TM Wrong on Mortar Clamp

MY TM—TM 9-2320-311-10-12—GIVES **BAD INFO** IN WP 0049 00 ON THE POSITION OF THE **MORTAR WIPER SEAL BAND CLAMP.**

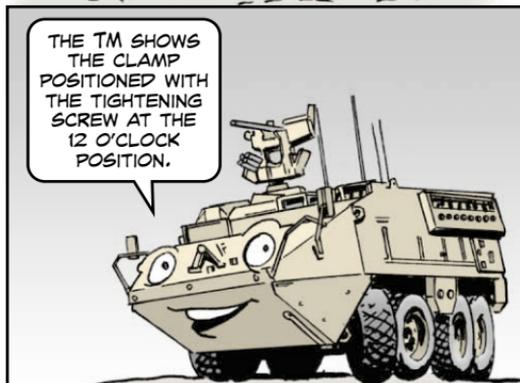
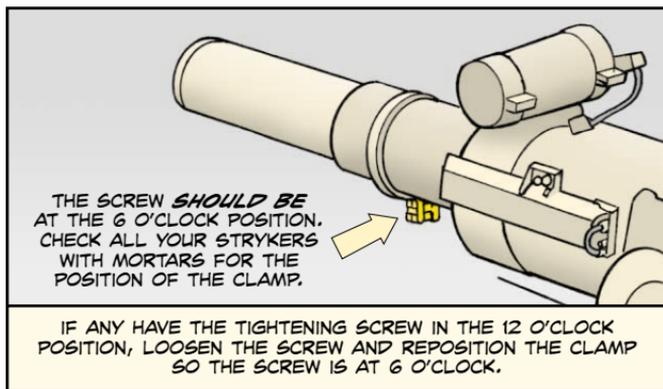
THE TM SHOWS THE CLAMP POSITIONED WITH THE TIGHTENING SCREW AT THE 12 O'CLOCK POSITION.

TROUBLE WITH THAT POSITION IS THAT THE SCREW MAY HIT THE REPLENISHER AND **DESTROY** THE CLAMP IF THE MORTAR EXPERIENCES EXCESSIVE RECOIL.

THE SCREW **SHOULD BE** AT THE 6 O'CLOCK POSITION. CHECK ALL YOUR STRYKERS WITH MORTARS FOR THE POSITION OF THE CLAMP.

IF ANY HAVE THE TIGHTENING SCREW IN THE 12 O'CLOCK POSITION, LOOSEN THE SCREW AND REPOSITION THE CLAMP SO THE SCREW IS AT 6 O'CLOCK.
